MANITOU SPRINGS CITY PLANNING COMMISSION REGULAR MEETING AGENDA

August 12, 2026

Title: VAR 2609 - Variance to allow artificial turf in Landscaped Area - 306 Canon Avenue
From: Fred Rollenhagen
To: City Planning Commission
Address of Proposal: 306 Canon Avenue
Applicant: Mark Wyant, President of Glenbrook Lodging Corp., owner of the Cliff House

Title: VAR 2605 & VAR 2606 - Setback Variance and Lot Coverage Variance at 2 Grand Avenue

THE CLIFF HOUSE AT PIKES PEAK FRONT LANDSCAPE AREA PLAN

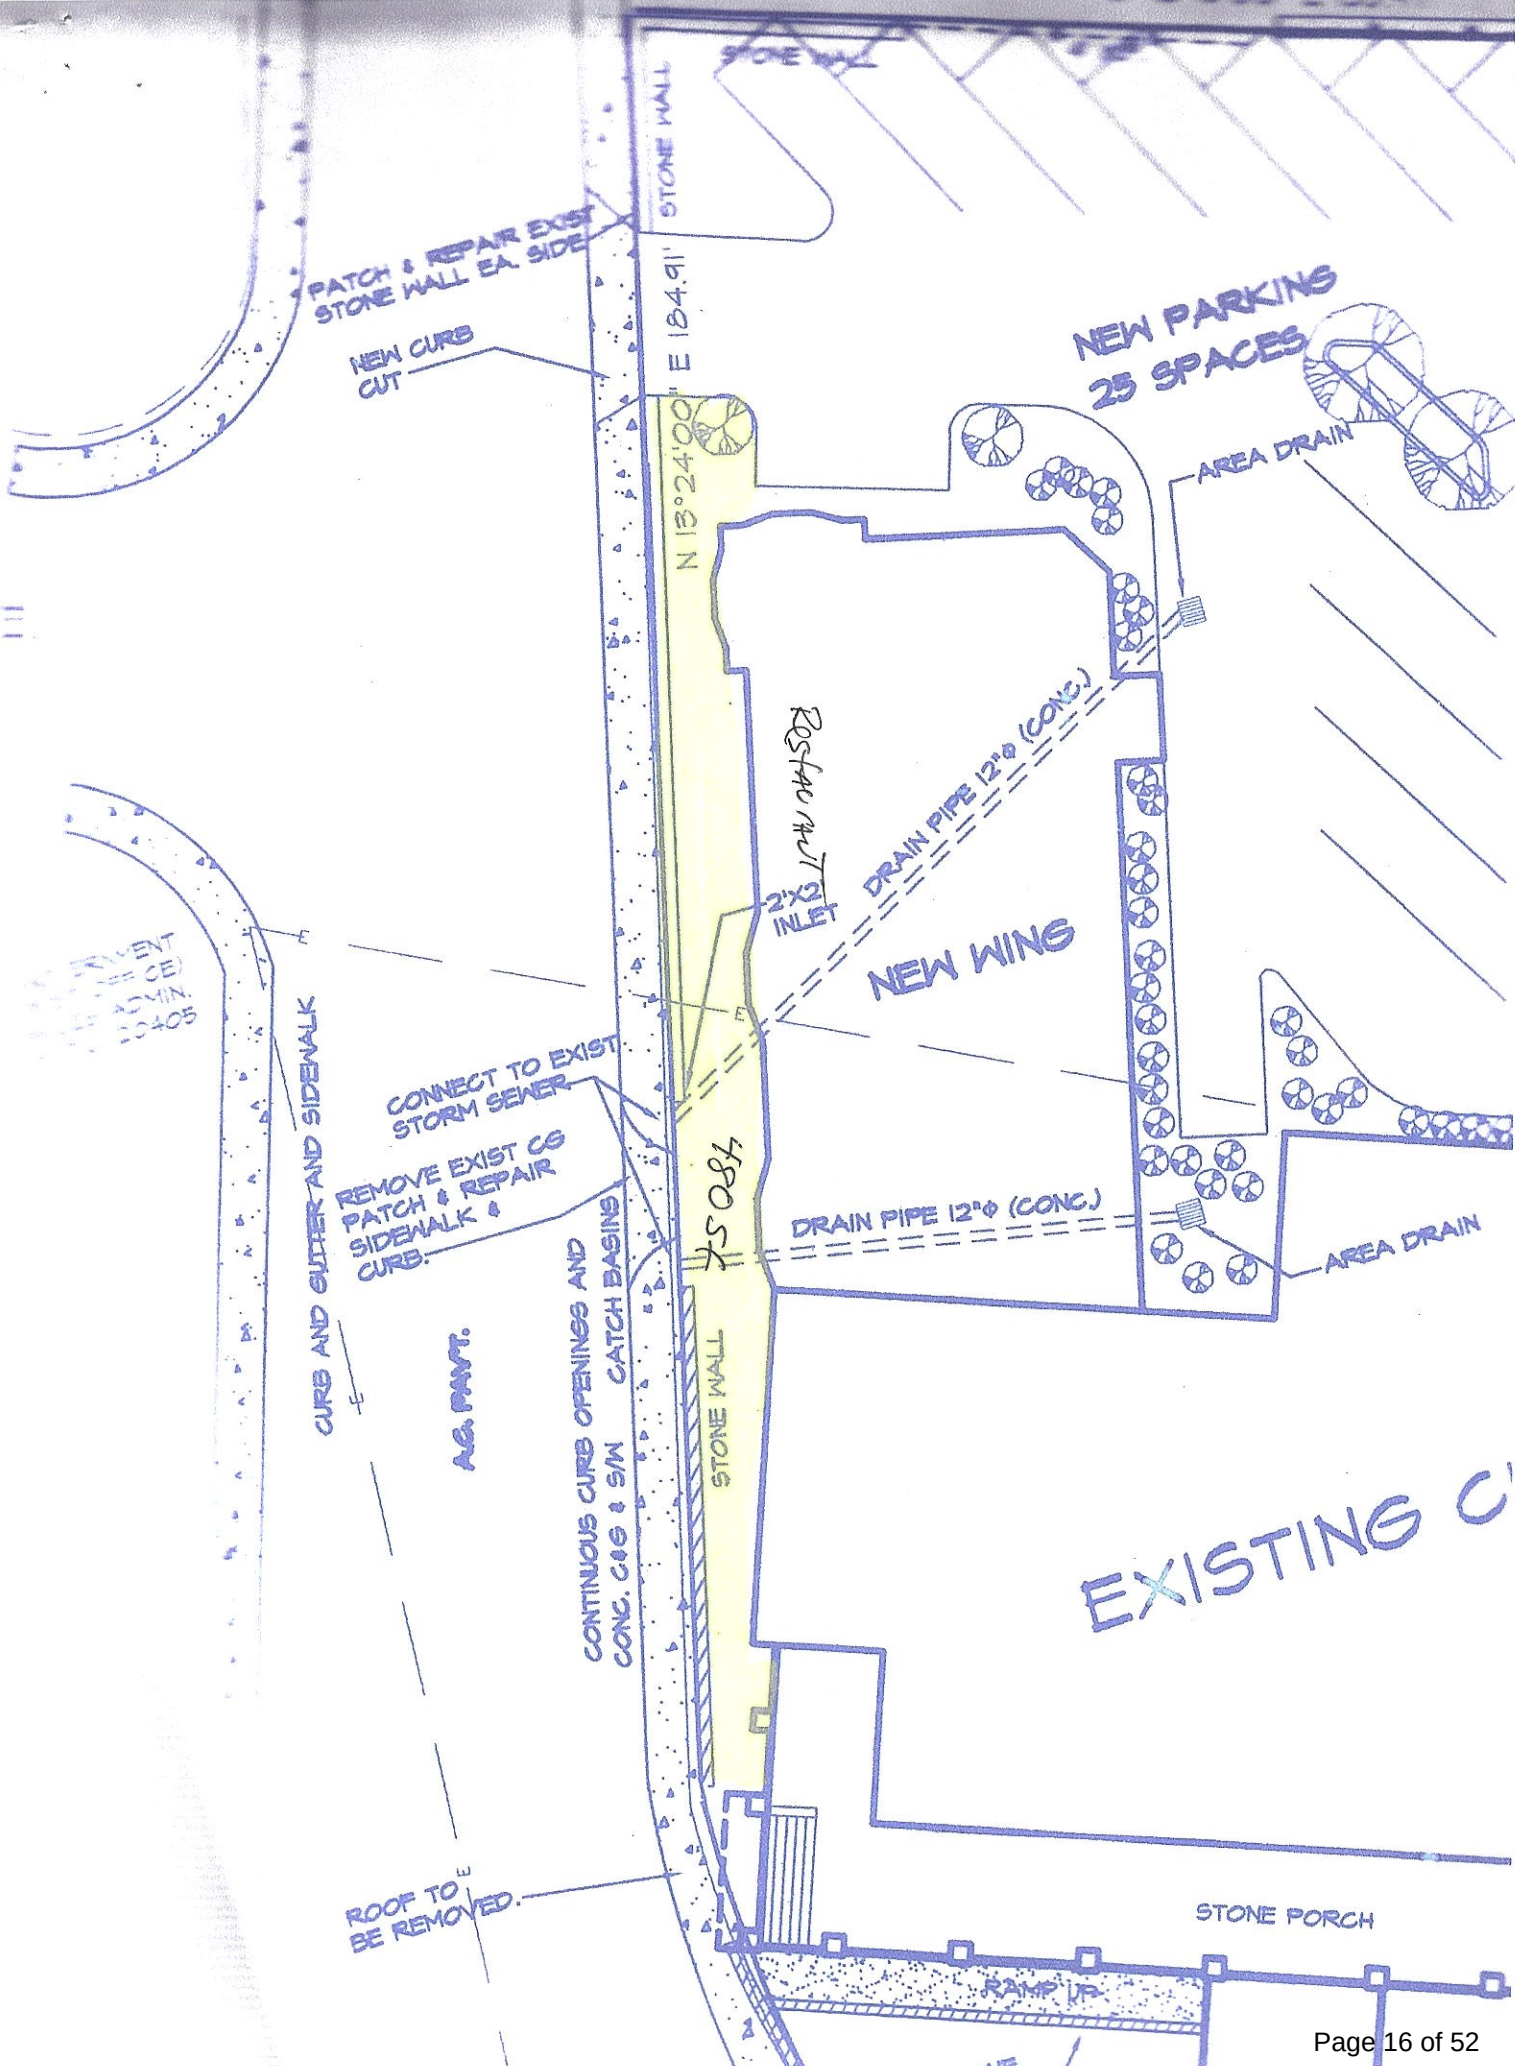
- According to the applicant's narrative, artificial turf is necessary for the planned croquet lessons and recreational play for hotel guests. Croquet requires an exceptionally smooth, level and durable playing surface that natural grass cannot provide due to weather, irrigation demands, maintenance requirements and foot traffic.

- According to the applicant's narrative, relocating the croquet area would either conflict with historic features, reduce usable guest space, or require greater disturbance to existing landscaping.

Staff is not aware of other properties in the Downtown zone district that have approved alternative landscaping materials.

The request to remove live vegetation and replace it with artificial turf is being made by the current property owner and applicant.

There does not appear to be a related disability affecting owners or tenants of the property related to this request.

The proposed application does not preserve a contributing structure in the historic subdistrict according to the application.

2 GRAND AVENUE CONDOMINIUMS

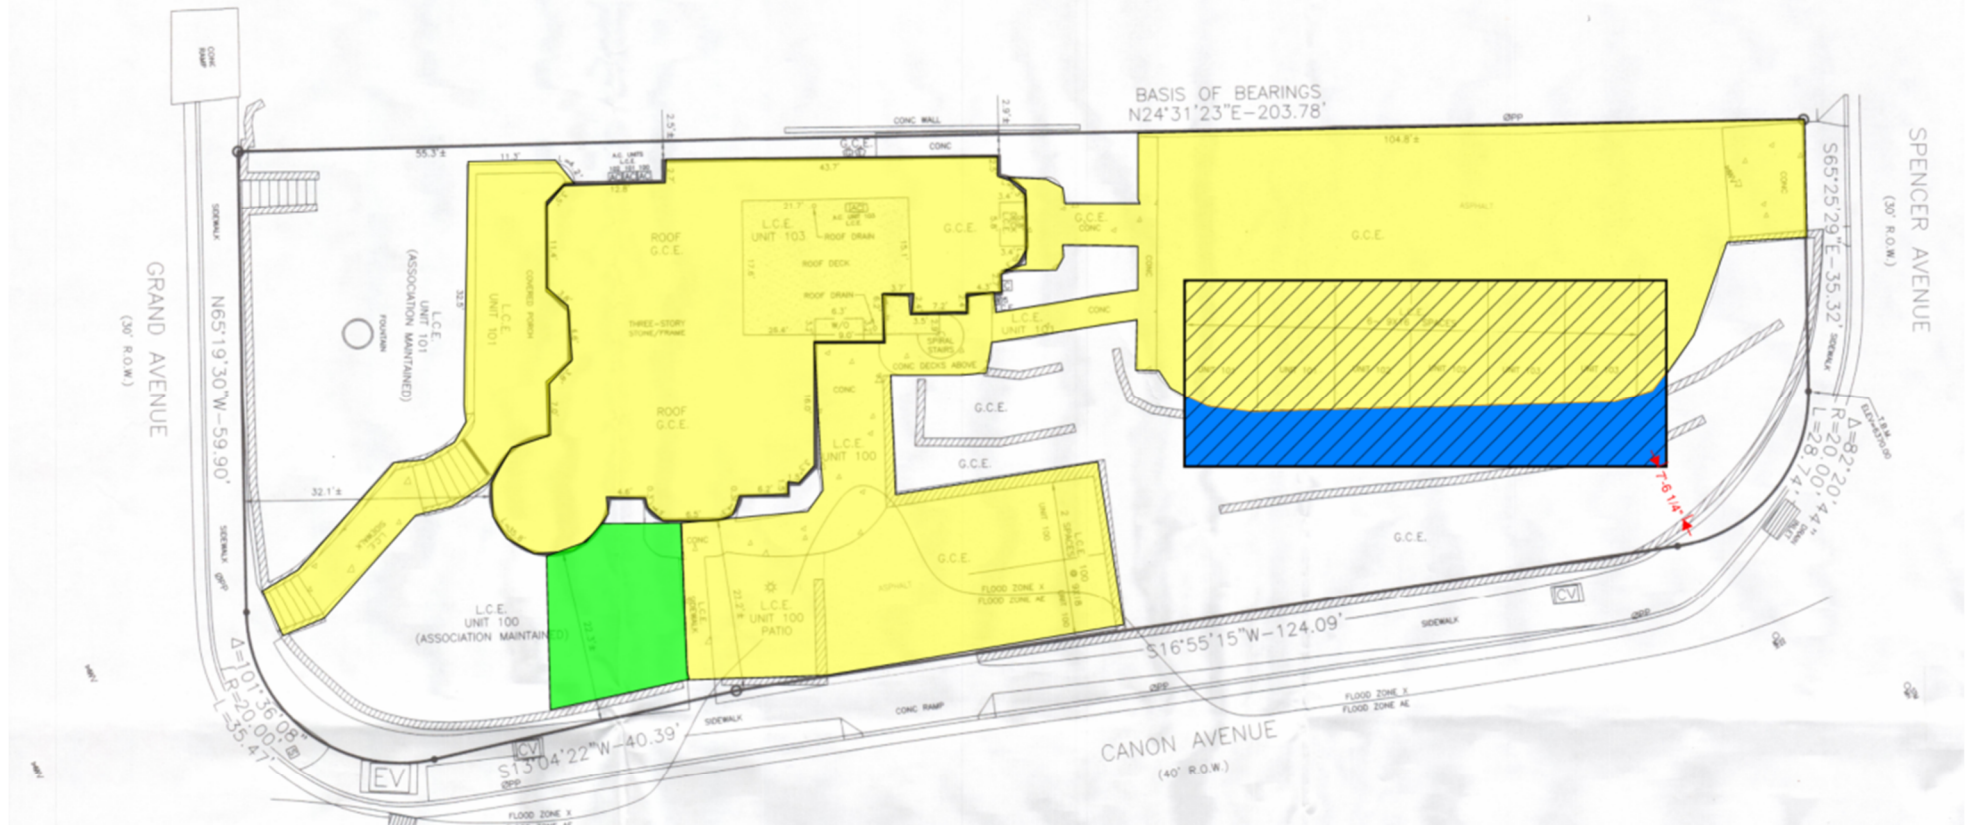
existing lot coverage	54%
lot coverage with artificial turf	57%
lot coverage with garage	58%
lot coverage with garage and turf	61%

2 GRAND AVENUE CONDOMINIUMS

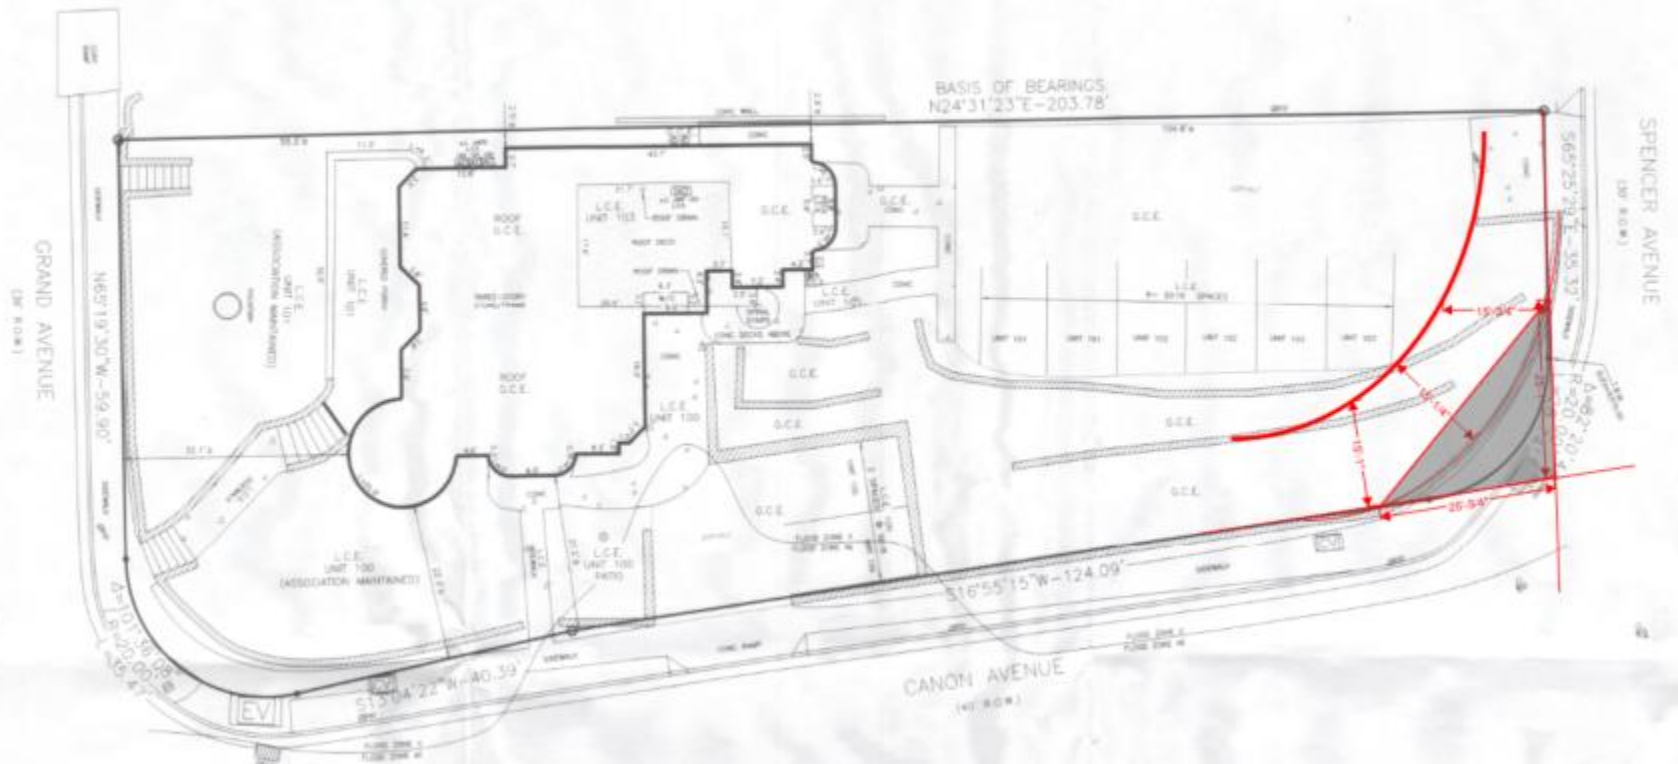
The gray triangle is the Vision Clearance Triangle

The proposed 7.5 foot setback would not encroach into the gray Vision Clearance Triangle.

2 GRAND AVENUE CONDOMINIUMS

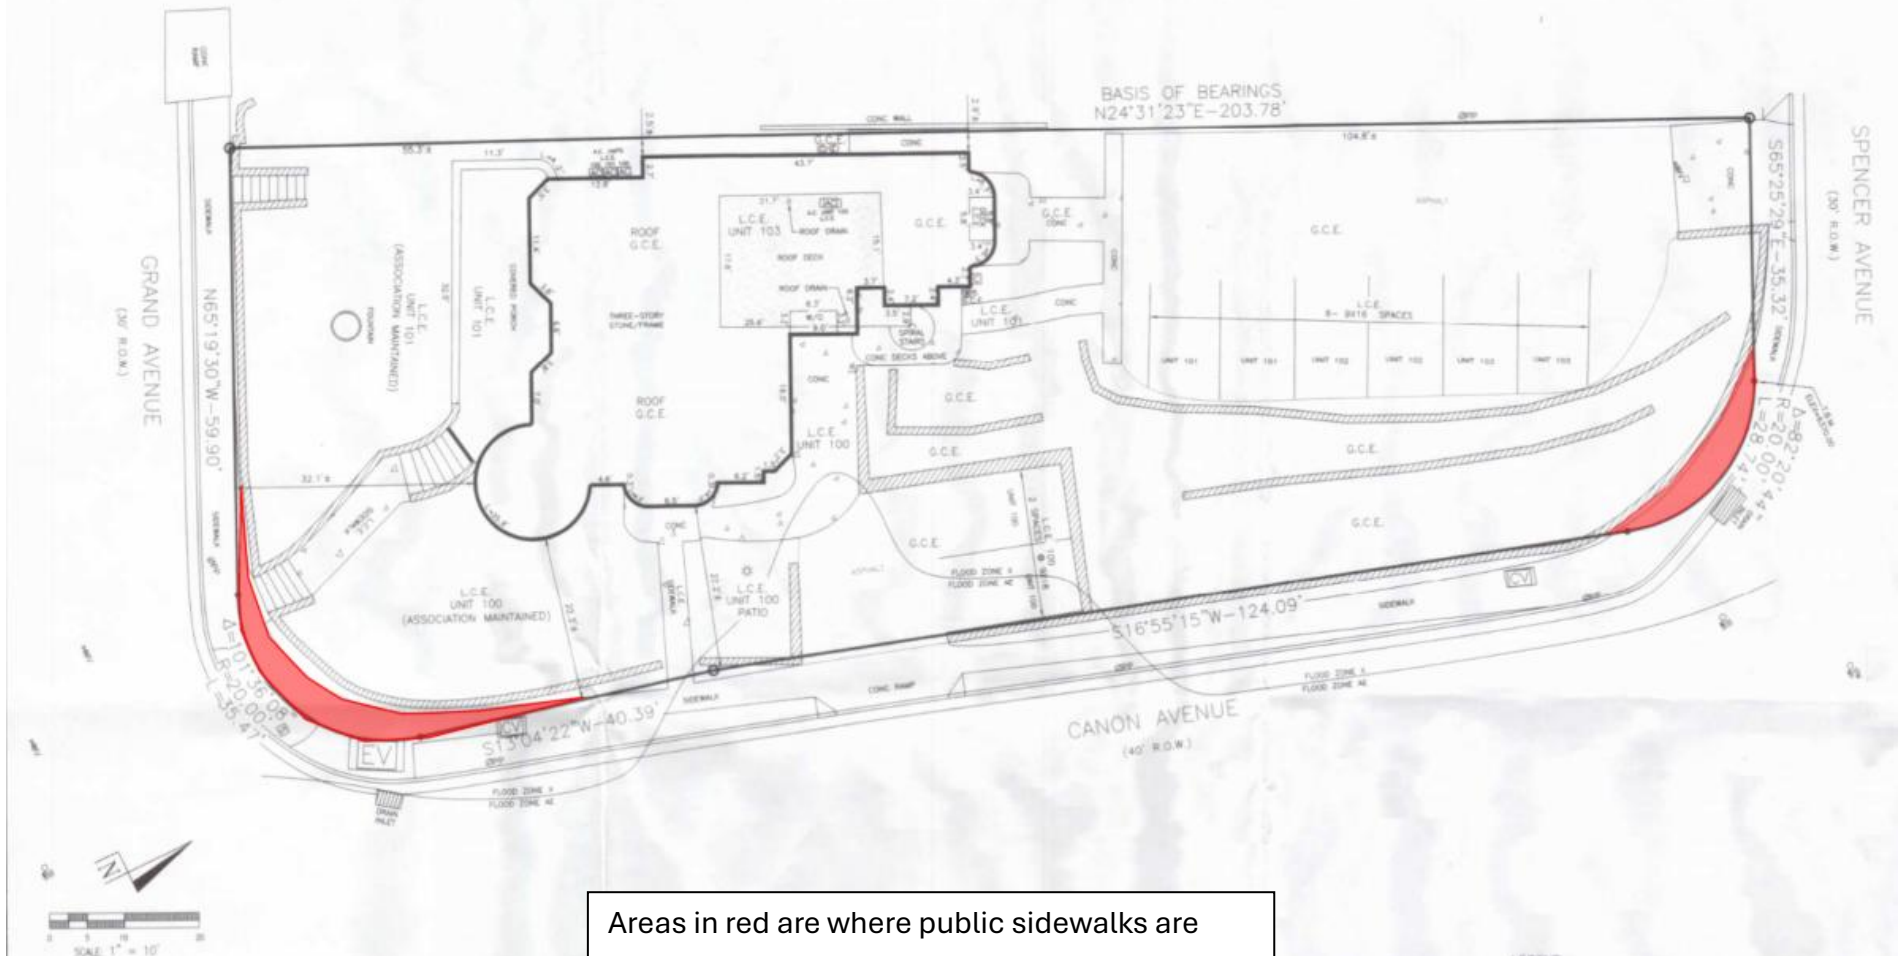
Areas in red are where public sidewalks are within the private property boundaries. In these cases, the setbacks are measured from the back of the sidewalk, rather than from the property boundary.
